Synapse
Energy Economics, Inc.

**Comments on Wolverine
Power Cooperative's *Electric
Generation Alternatives
Analysis* for the Proposed
Rogers City Coal Plant**

July 8, 2009

Figure Synapse-1: Cost Estimates for Wolverine’s Proposed Rogers City Coal Plant vs. Cost Estimates for Other CFB Coal Plants and Coal Plants Proposed for Michigan.

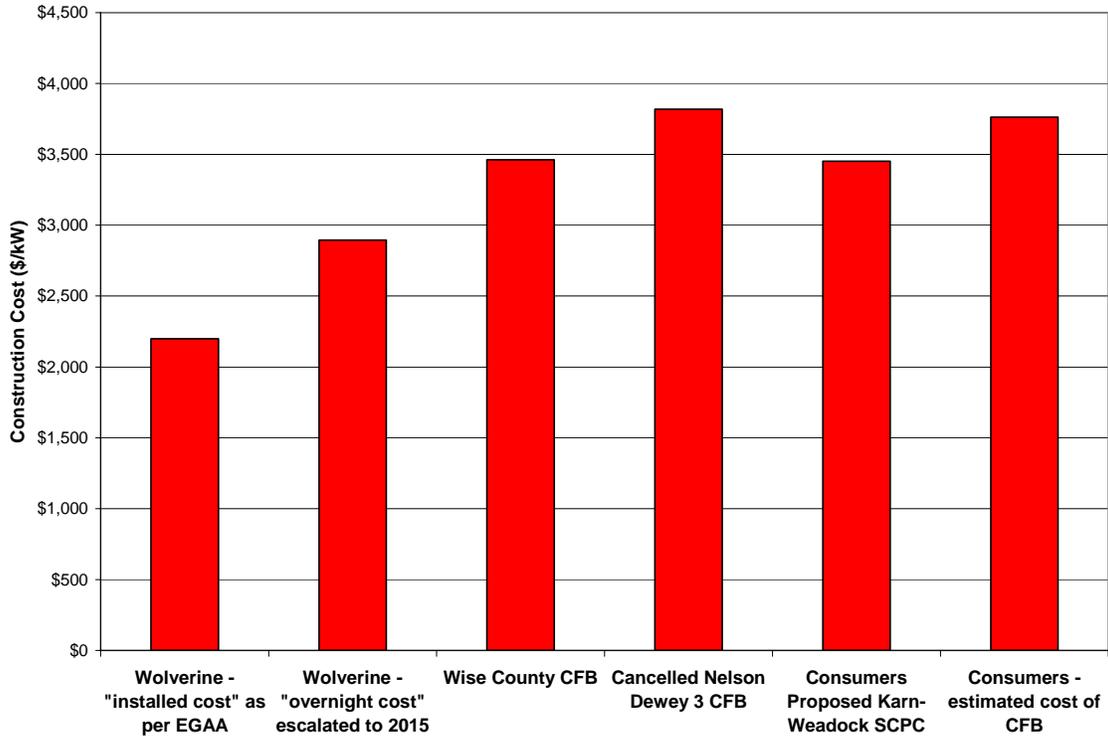
As shown in Figure Synapse-1 and Table Synapse-1 below, Wolverine's estimated cost for its proposed Rogers City project is significantly lower than recent cost estimates for other proposed coal plants.

Thus, the conclusion is the same whether you assume that the \$2,200 per kW construction cost presented in the EGAA is an “installed cost” or an “overnight cost:” the estimated coal cost that Wolverine used in the economic analyses in the EGAA is much lower than the costs of other recently estimated CFBs, and is lower than the cost estimate for Consumers Energy’s proposed Karn-Weadock plant. Based on these other estimates,

it would have been more reasonable for Wolverine to use a CFB coal plant cost of \$3,500 per kW to \$3,800 per kW in its economic analyses.

Figure Synapse-2: Emissions reductions that would be required under the Waxman-Markey climate change legislation introduced in the current 111th U.S. Congress.

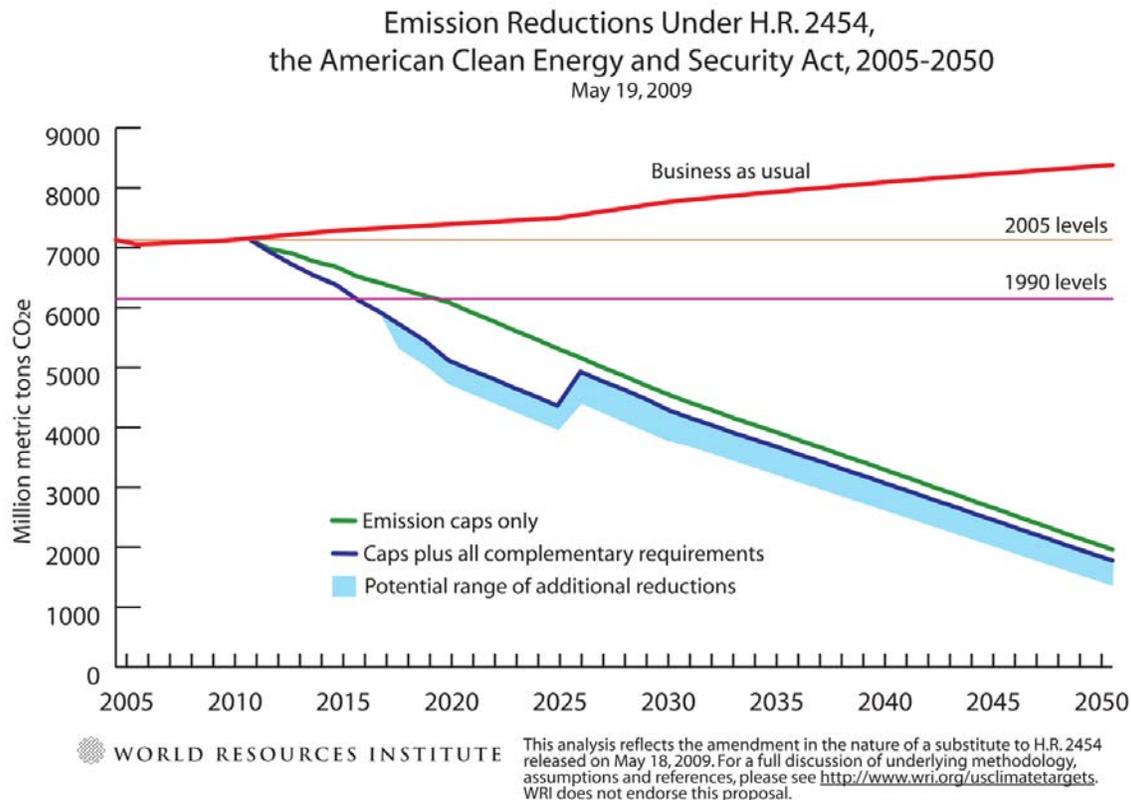
Figure Synapse-2, below, shows the emissions trajectories that would be mandated under the proposed Waxman-Markey legislation. These trajectories aim for emissions

reductions of 83 percent from 2005 levels by 2050, similar to the plan recently announced by the Obama Administration.

Figure Synapse-3: Synapse 2008 vs. Wolverine CO₂ allowance price forecasts.³¹

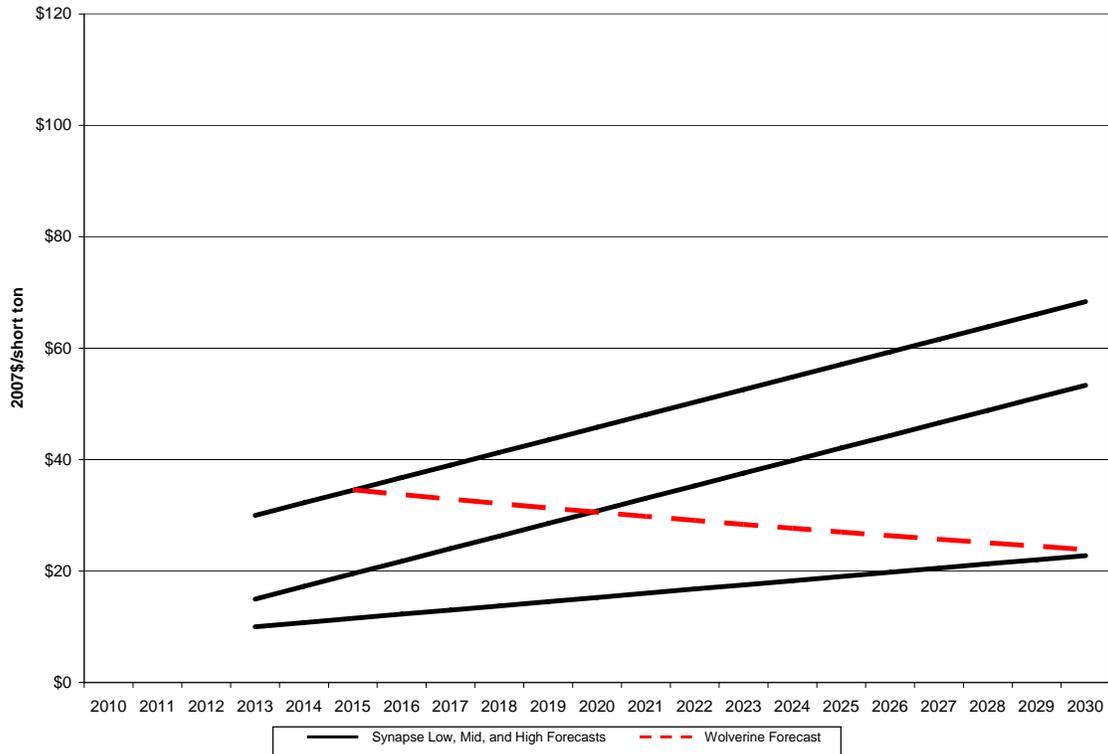
Wolverine has said that it used a \$42.14/ton CO₂ price in its least cost planning analyses.²⁶ However, this cost appears to be in nominal dollars rather than to be a levelized cost over a period of years. Moreover, as indicated above, the very low levelized prices for the coal and gas alternatives presented in Table 6.4 and Figure 6.6 of the EGAA suggest that Wolverine did not assume any CO₂ costs in these analyses. That is a fatal flaw.

Based on a number of factors, including our assessment of the results of these modeling analyses, Synapse has developed a set of CO₂ price forecasts that we believe provides a reasonable range of possible future CO₂ allowance values. The current Synapse CO₂ price forecasts are compared to Wolverine's \$42.14/ton figure (in nominal dollars) in Figure Synapse-3 below:

The 2008 Synapse CO₂ Price Forecasts shown in Figure Synapse-3 are all in 2007 dollars. The Synapse Low CO₂ Price Forecast starts at \$10/ton in 2013 and increases to approximately \$23/ton in 2030. This represents a \$15/ton levelized price over the period 2013-2030. The 2008 Synapse High CO₂ Price Forecast starts at \$30/ton in 2013 and rises to approximately \$68/ton in 2030. This High Forecast represents a \$45/ton levelized price over the period 2013-2030. Synapse also has prepared a Mid CO₂ Price Forecast that starts close to the low case, at \$15/ton in 2013 and climbs to \$53/ton by 2030. The levelized cost of this Mid CO₂ price forecast is \$30/ton.

Figure Synapse-4: CO₂ prices used by Synapse and Wolverine vs. results of modeling analyses of major bills in the U.S. Congress – levelized CO₂ prices (2013-2030, in 2007 dollars).³³

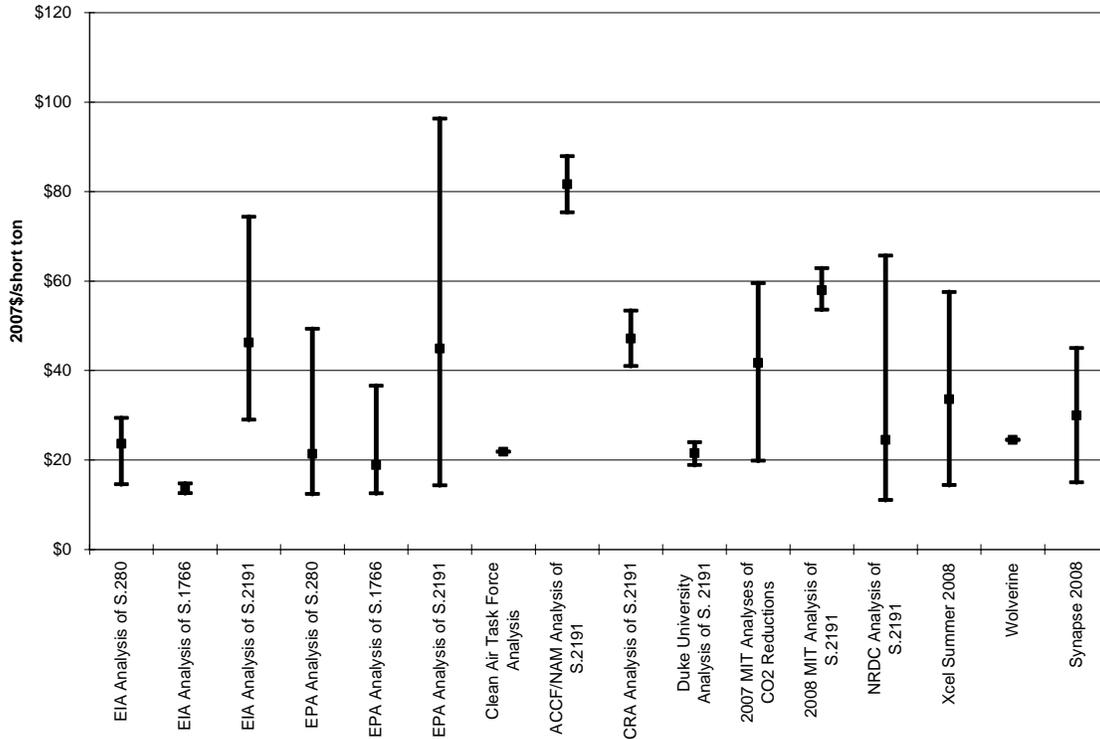
Figure Synapse-4, below, compares the levelized CO₂ cost used by Wolverine and the range of CO₂ prices that Synapse recommends be used for resource planning with the results of the modeling analyses of the major climate change bills that have been proposed in the U.S. Congress. As can be seen, the CO₂ prices recommended by Synapse are very reasonable compared to the range of CO₂ emissions allowance prices that could have resulted from adoption of the major greenhouse gas regulatory legislation that has been considered in the U.S. Congress. In fact, under many possible scenarios, CO₂ allowance prices could substantially exceed the high ends of the price range that Synapse recommends for use in resource planning assessments.

In fact, there are a significant number of possible scenarios where CO₂ emissions allowance prices could be substantially higher than the CO₂ price that Wolverine used in the EGAA.

Figure Synapse-5: The State of Michigan’s Historic and Future CO₂ Emissions compared to the Emission Levels that Would Be Consistent with the National CO₂ Caps in the proposed Waxman-Markey Legislation.

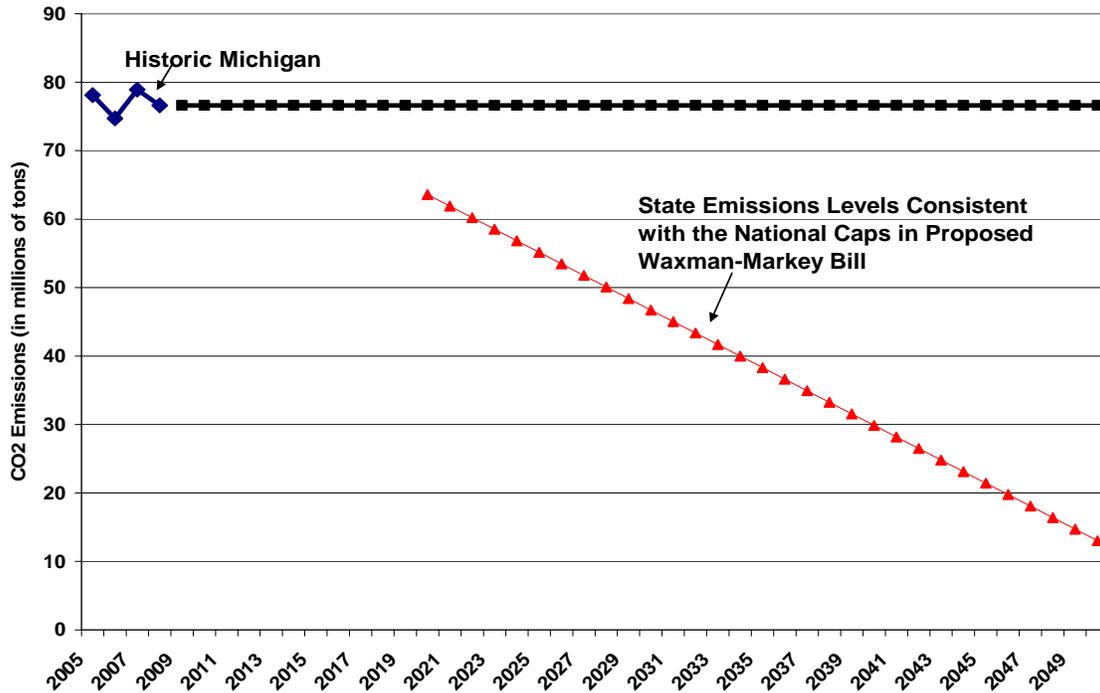
Figure Synapse-5, below, shows Michigan’s recent statewide CO₂ emissions and the emission levels that would be consistent with the national caps in the Waxman-Markey legislation. As can be seen, substantial overall reductions in the state’s CO₂ emissions will be required during the coming decades.

If Michigan replaces old coal units with new coal plants, it will have to purchase substantial amounts of expensive allowances or offsets to meet the declining federal caps. On the other hand, if the state gradually replaces old coal with cost-effective energy efficiency, renewables, and, to the minimum amount necessary, gas, it would put itself into a position of possibly being able to sell allowances into the national market to the benefit of ratepayers and the economy.

Figure Synapse-6: Natural Gas Prices – Table 13 of March AEO Used by Wolverine vs. ECAR Region Gas Prices Forecast in Table 72 of the March 2009 AEO and Table 72 of April 2009 AEO.

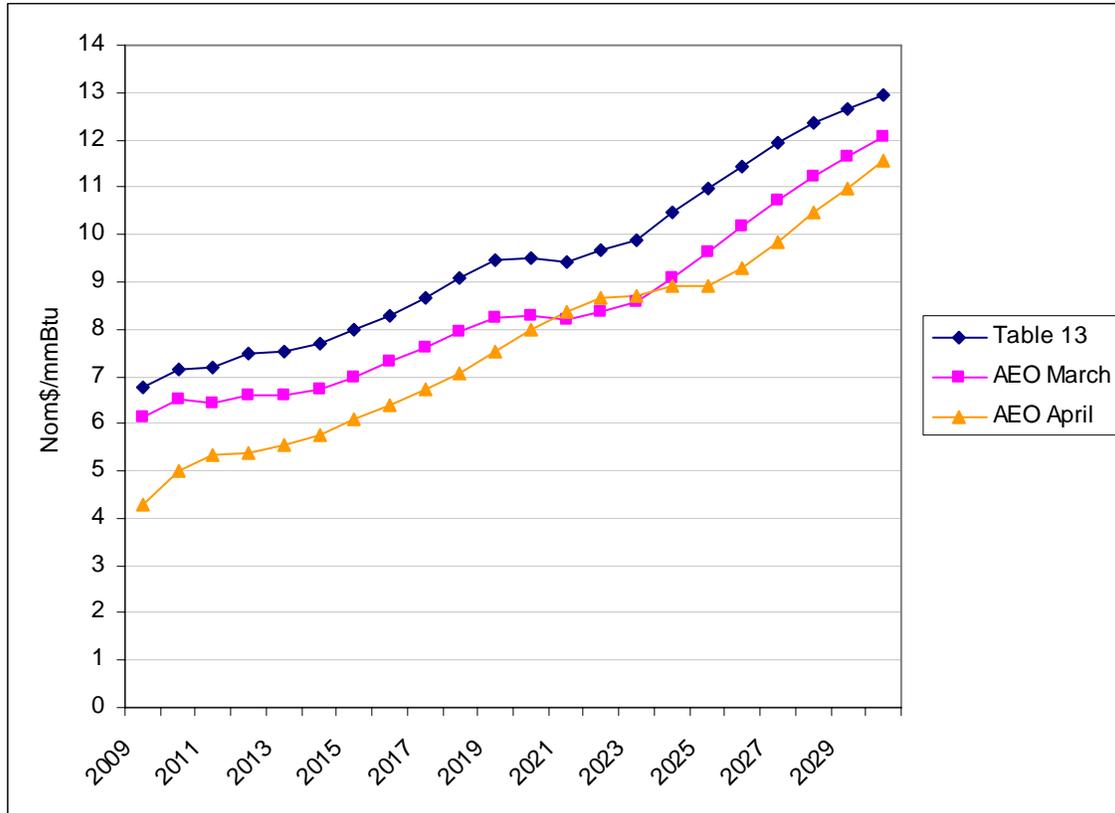
Wolverine has said that the \$7.99/MMBtu base case gas price shown in Figure 4.6 in its EGAA “is from Table 13 of the Energy Information Administration (EIA) Annual Energy Outlook released March 2009.”³⁶ A review of this Table, however, suggests two significant flaws. First, the \$7.99/MMBtu cost used by Wolverine appears to be for the year 2015 rather than representing a levelized cost for a longer planning period. Second, Table 13 in the AEO represents an average natural gas price for the entire nation, that includes higher priced locations on the east and west coasts.

The gas price projections included in Table 72 of the AEO for the ECAR region are significantly lower than the national gas prices included in Table 13, as can be seen from Figure Synapse-6 below.

As noted above, in the absence of workpapers, it appears that the \$7.99/MMBtu natural gas that Wolverine assumed in its cost analyses in the EGAA was taken from the value for the year 2015 in Table 13 of the March 2009 AEO. The comparable natural gas price in the March 2009 AEO for 2015 for the ECAR region was only \$6.07/MMBtu, or approximately 24 percent lower than the figure used by Wolverine. The comparable natural gas price in the April 2009 AEO for 2015 for the ECAR region was only \$5.31/MMBtu, or nearly 34 percent lower than the figure used by Wolverine.

Figure Synapse-7: The relationship between CO₂ emissions allowance prices and natural gas prices.

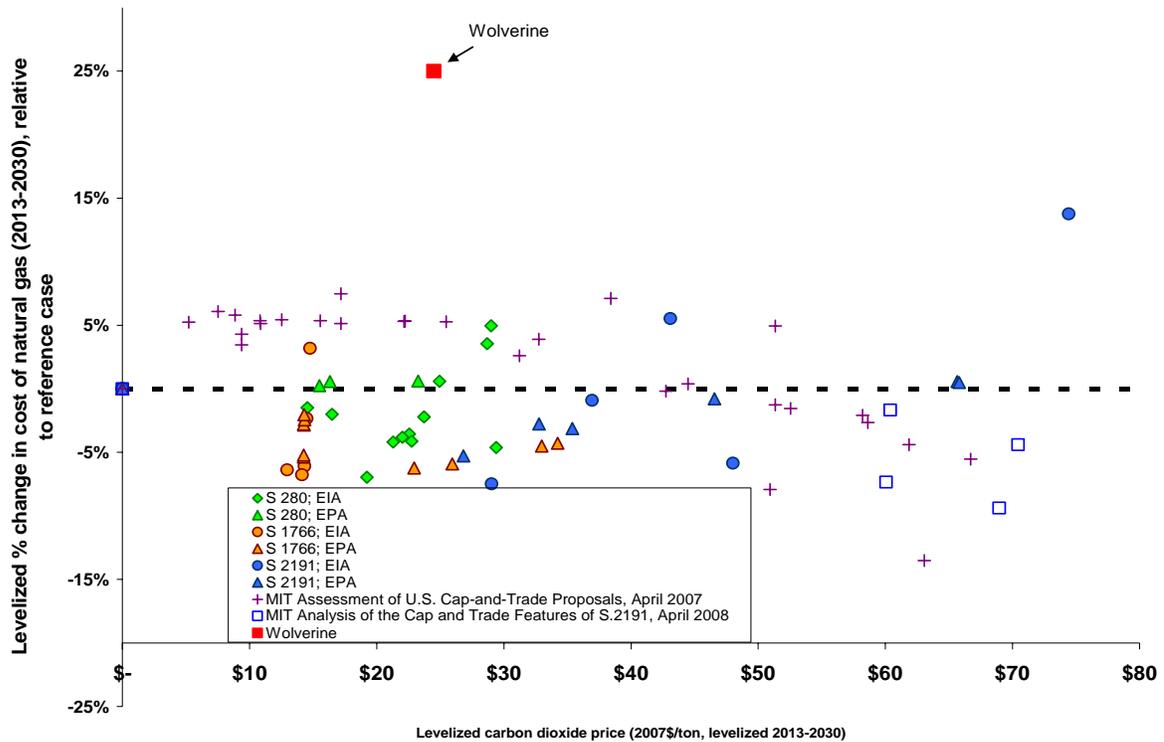
Figure Synapse-7, below, shows the levelized percentage changes in natural gas prices (i.e., increases or decreases from the base case with no regulation of greenhouse gas emissions) in scenarios reflecting the major climate change proposals in the U.S. and the levelized CO₂ prices in those scenarios. The data presented in Figure Synapse-7 has been developed from the results of modeling by the Joint Program at the Massachusetts Institute of Technology (“MIT”) on the Science and Policy of Global Change, the U.S. EPA, and the Energy Information Administration (“EIA”) of the Department of Energy , and cover multiple climate change proposals in the 110th U.S. Congress: Senate Bill S.280 (the McCain-Lieberman bill), Senate Bill S.1766 (the Bingaman-Specter bill) and Senate Bill S.2191 (the Lieberman-Warner bill).

As shown clearly in Figure Synapse-7, Wolverine has assumed that there would be a very significant increase (that is, 25 percent) in the price of natural gas at a relatively low levelized CO₂ price. This assumption is not supported by the results of the independent modeling analyses of carbon dioxide regulation. Instead, as can be seen from Figure Synapse-7, in all but one of the scenarios studied, federal regulation of greenhouse gas emissions would have a much smaller impact on natural gas prices than Wolverine has assumed – and that single scenario featured a levelized CO₂ price of approximately \$75/ton, a far higher price than Wolverine has assumed for the least cost planning studies included in the EGAA. In fact, in some of the carbon regulation scenarios represented in Figure Synapse-7, the models forecast that the adoption of greenhouse gas regulation might lead to lower natural gas prices as demand for and use of natural gas declined due to its greenhouse gas emissions. Thus, there is no evidence to support Wolverine’s assumption that federal regulation of greenhouse gas emissions would inevitably lead to a 25 percent or higher increase in the price of natural gas, particularly at relatively low CO₂ prices.
